# Response to Submissions

State Significant Development Application  
SSD-78669234

27-29 Tryon Road, Lindfield

4 December 2025

Figure 9 Saved TOD sites surrounding the site (Source: Gyde)

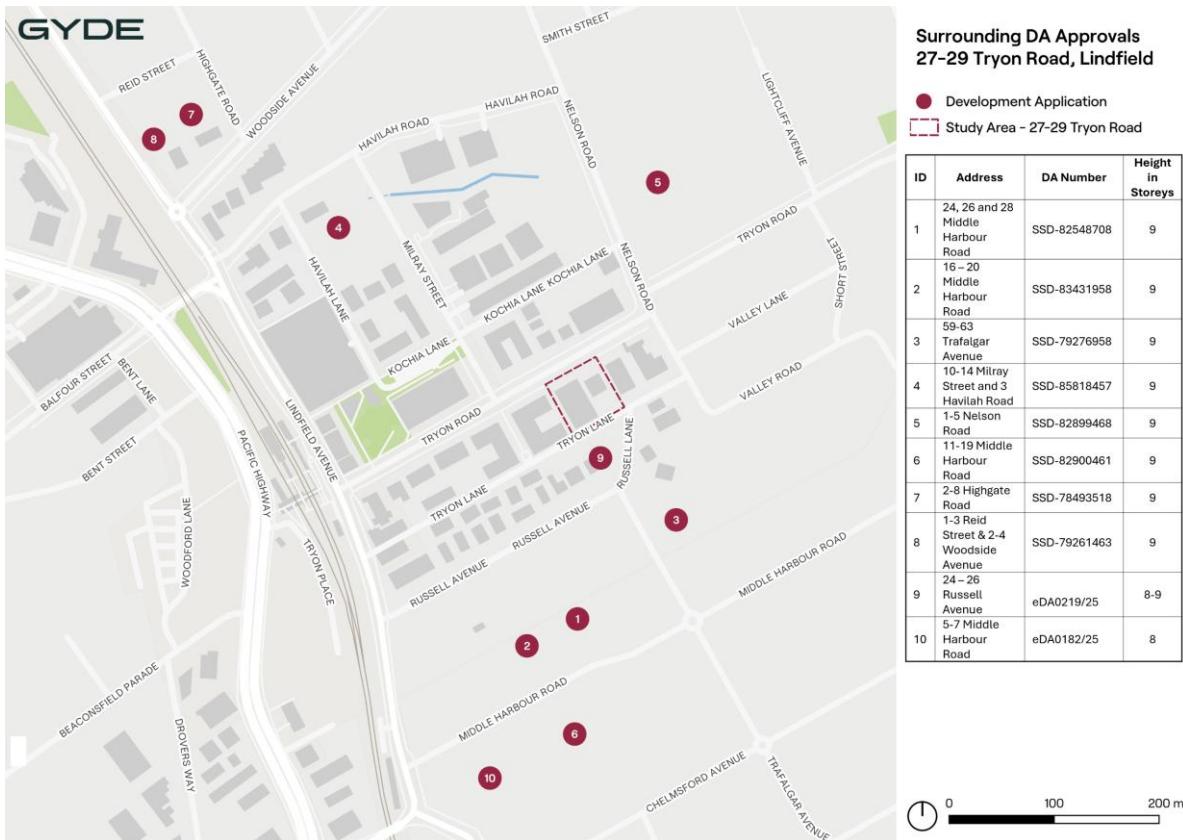
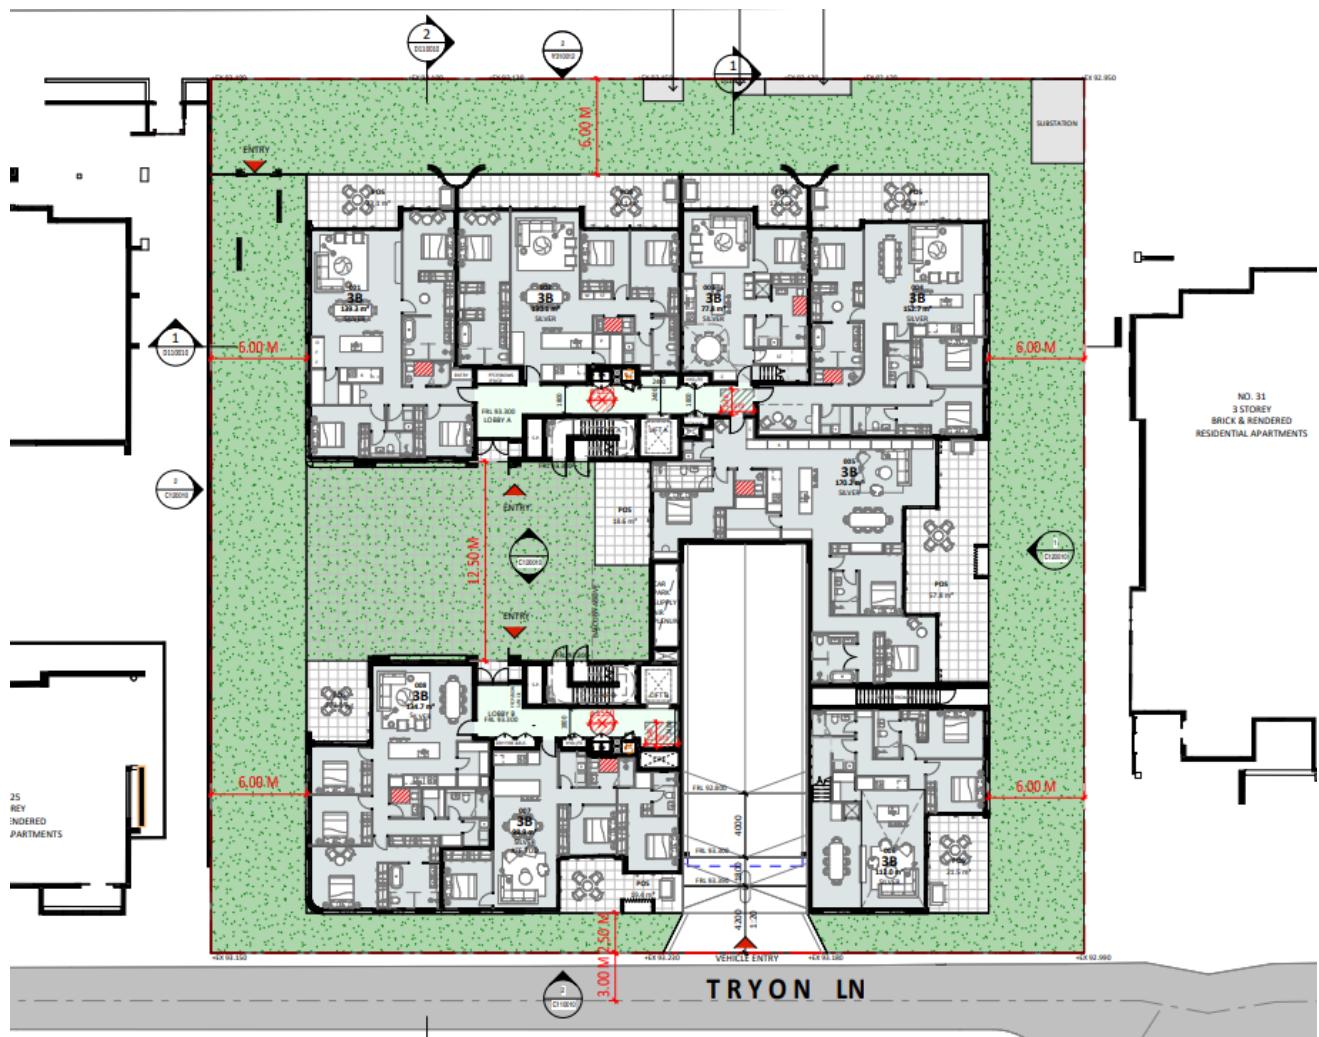
As noted in the Request for Additional Information letter, Chapter 5 of the Housing SEPP relating to Transport Orientated Development no longer applies to the Ku-ring-gai local government area, with the exception of lots that on, or before, 13 June 2025, had valid SEARs and SSD applications lodged but not yet determined. The site being 27-29 Tryon Road, Lindfield was lodged on 2 April 2025 and has therefore been saved under the transitional provisions and mapped on the revised TOD Map as shown in Figure 1.

As shown in Figure 9, the site and the site immediately to the rear have been saved under the TOD. This will result in increased density to the rear of the site as well, with a likely development for a residential flat building of up to 9 storeys. Figure 9 also shows other saved TOD sites within the immediate surrounding area, all of which has lodged a DA or SSDA proposing residential flat buildings of up to 9-storeys.

The proposed development is therefore consistent with the desired future character of the area, particularly along Tryon Road and Russell Avenue to the rear which is anticipated to increase the existing density of the area. With a building height compliant with the TOD controls plus a 30% in-fill affordable housing bonus (which is applicable to most sites in the R4 zone), the development steps down from the maximum permissible building heights to the west and creates a residential flat building that delivers much needed housing, including affordable housing, in a well-located area.

Figure 13 Site Isolation Concept Plan (Source: PTW)

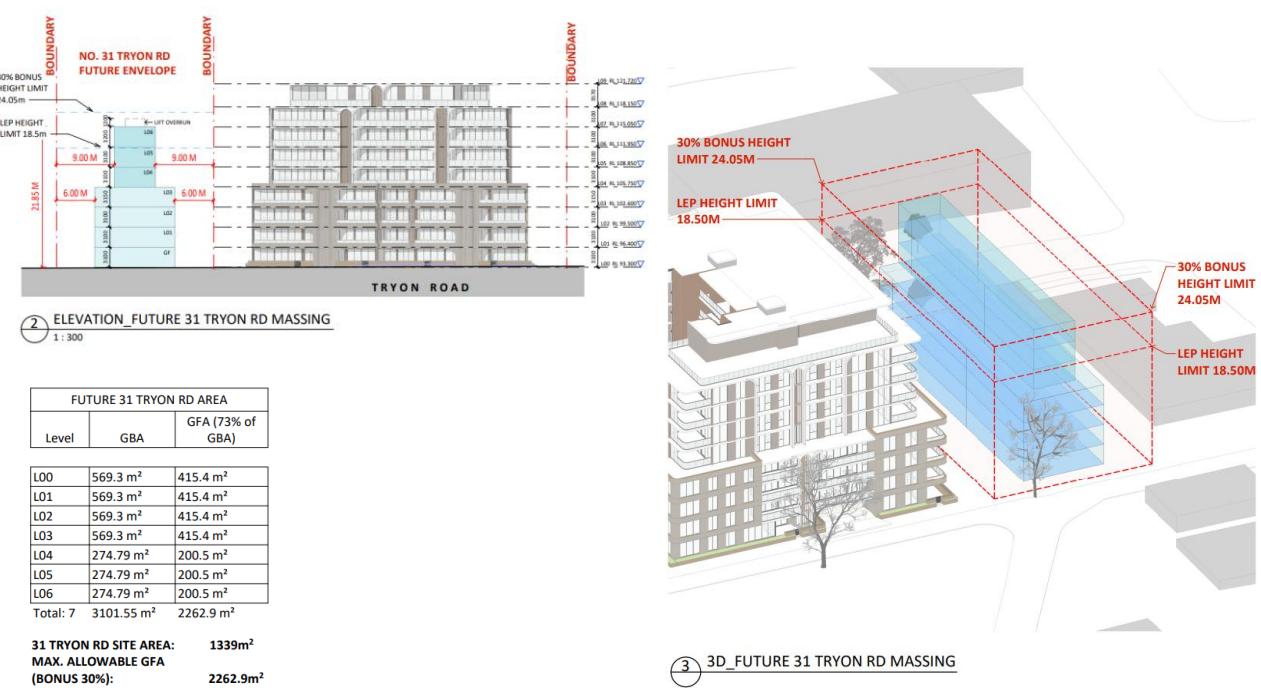
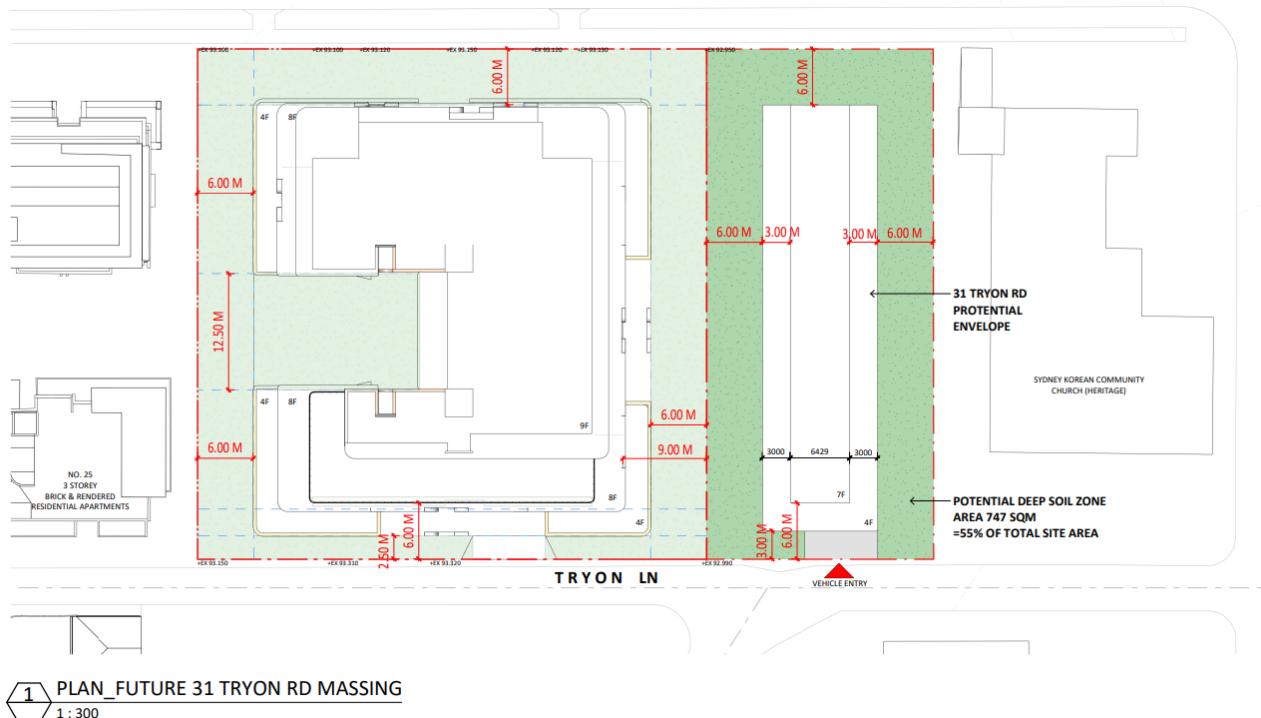
A concern was raised by DPHI as to whether the site at 31 Tryon Road would become an isolated site based on these amended controls, as the site falls within Area 3 of the revised Lot Size Map meaning Clause 6.6(5) applies. The site at 31 Tryon Road has a street frontage of 24m, however the lot size is less than 1500sqm (being 1339sqm). Therefore, whilst under the current planning controls this site could be development for the purposes of a residential flat building, under the revised controls, the site would no longer meet the minimum lot size. We note that the minimum lot size is a development standard under the LEP and is not excluded from the use of Clause 4.6 variation requests. Therefore, this minor non-compliance could be varied in the interests of promoting the highest and best use for the site.

Analysis has been undertaken by PTW to determine whether the site could be developed in isolation to satisfy the DPHI concerns. The analysis found that the site could be redeveloped for a 7-storey residential flat building with in-fill affordable housing as shown in Figure 13. Utilising the 30% bonus height and FSR provisions of the in-fill affordable housing bonus on top of Council's amended planning controls, the site could be redeveloped with a FSR in the order of 1.69:1 and a maximum building height of 24.05m, with appropriate building separation distances and deep soil in excess of 50% of the site area.

Based on the site isolation analysis and given that this site already comprises a 3-storey residential flat building, this site is not isolated as a result of the proposed development.

Figure 14 Proposed Level 4-6 Plan showing setbacks (Source: PTW)

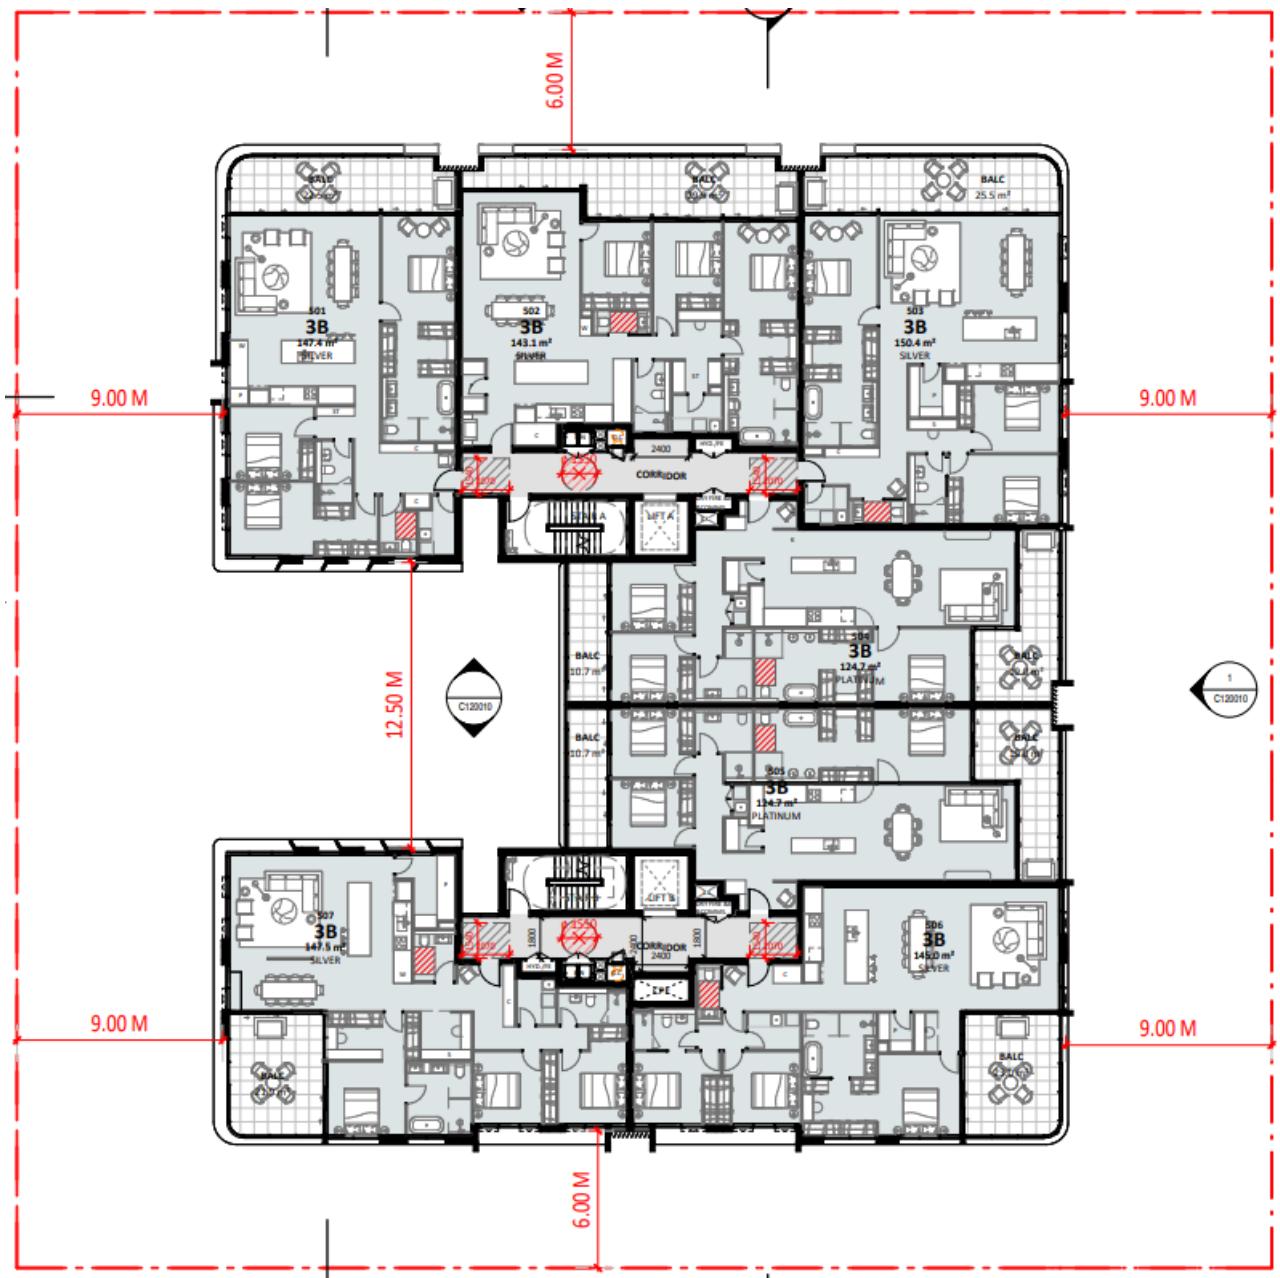
- DPHI acknowledged the attempt to largely comply with the ADG in terms of building separation distances, noting they understand the tension between TOD and the ADG. DPHI have a preference for full compliance but would consider minor variations appropriate to the site context.

The side setbacks to the east and west elevations have been increased to a compliant 6m setback up to the 4<sup>th</sup> storey. Level 4-7 increase the setbacks to 9m from the side boundaries and Level 8 comprises 12m side setbacks, as shown in Figure 14.

The proposed setbacks are compliant with the Apartment Design Guide (ADG) design criteria to ensure that the development contributes positively to the amenity of surrounding developments and character of the area. The increased setbacks also remove the reliance on blank walls to the east and west boundaries, improving the design quality of the building as well as amenity for residents in terms of solar access and ventilation.

Figure 15 Proposed basement plan showing setbacks (Source: PTW)

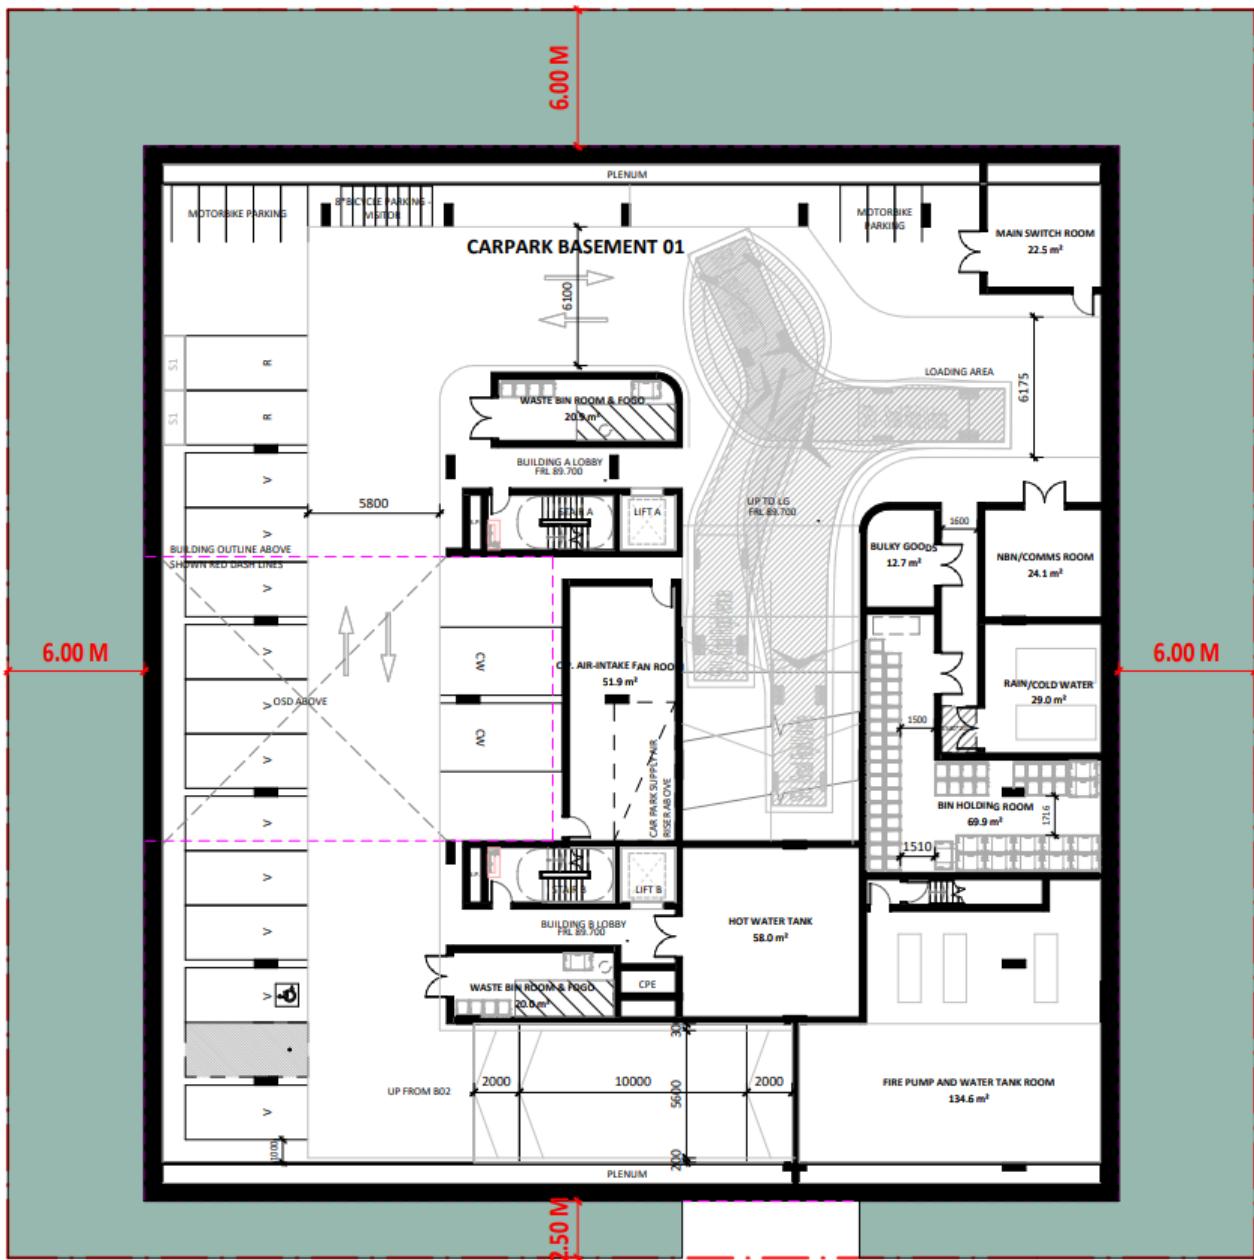
- DPHI noted they are looking for basement setbacks on all boundaries, which typically should be the same as the building footprint.
- DPHI were happy with the proposed waste collection area within the basement.

The basement setbacks have been increased to 6m from the north, east and west boundaries and 2.5m to the south boundary as shown in Figure 15.

The reduced basement footprint has enabled an increase in deep soil landscaping on the site and has resulted in a reduction in car parking numbers which now align with the Housing SEPP controls, both outcomes are discussed in more detail below.
